Access Compliance Report

Public Rights-of-Way

Intersection ID: 46147	Main Street: ROCKY_FORD_CLUB_RD	Cross Street: ARBOR_CREEK_DR	Location: SE
ADA ID: 52EC59FEA38B	Ramp Type: PerpDiag	Initial Pass/Fail: Pass	Overall Compliance: No
Severity Score: 7.5			
Codes/Mitigation Info/Possible Solution		Field Measurements/Component Compliance

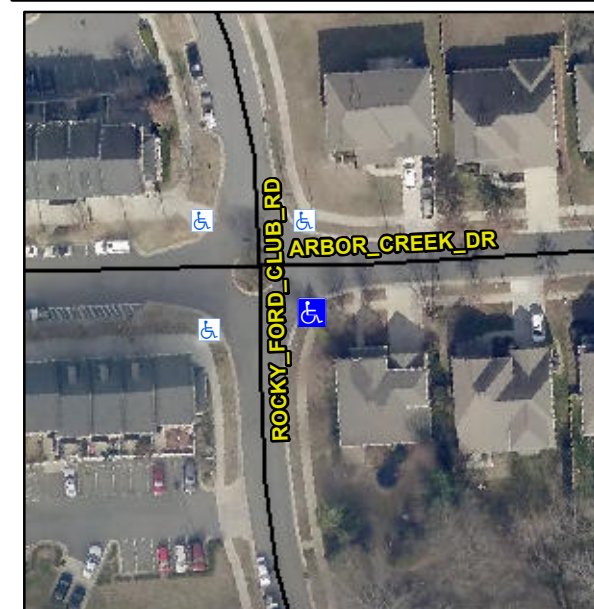
R304.2.1, R305.2, R302.7, R302.7.2, R304.5.3

Compliance	Description	Data	Compliance	Description	Data
N/A	Ramp Length (in)	72.0	Yes	Ramp Slope (%)	5.2
Yes	Ramp Width (in)	48.0	Yes	Ramp XSlope (%)	1.2
N/A	Flare Type LT	Sloped	N/A	Flare Type RT	N/A
N/A	Flare Slope LT (%)	1.2	N/A	Flare Slope RT (%)	5.1
N/A	Flare Traversable LT?	No	N/A	Flare Traversable RT?	No
Yes	Landing Length (in)	60.0	Yes	DWS Provided?	Yes
No	Landing Width (in)	41.0	Yes	DWS Contrast?	Yes
Yes	Landing Slope (%)	0.4	Yes	DWS Length (in)	25.5
Yes	Landing X Slope (%)	0.7	Yes	DWS Full Width?	Yes
N/A	Landing Curb? (Y/N)	No	No	DWS Offset (in)	3.5
N/A	Shared Landing?	No			
No	Gutter Ponding?	Yes	Yes	Gutter Slope (%)	1.1
No	Gutter Lip Ht (in)	0.5	No	Gutter X Slope (%)	2.1
N/A	Painted X Walk1?	No	N/A	Painted X Walk2?	No
	X Walk 1 Direction	To N		X Walk 2 Direction	To W
N/A	X Walk 1 Width (in)	N/A	N/A	X Walk 2 Width (in)	N/A
	X Walk 1 Slope (%)	3.5		X Walk 2 Slope (%)	5.6
	X Walk 1 X Slope (%)	1.2		X Walk 2 X Slope (%)	5.9

Remove & Replace Curb Ramp With Two New Directional Ramps or Equivalent. Remove & Replace Gutter.
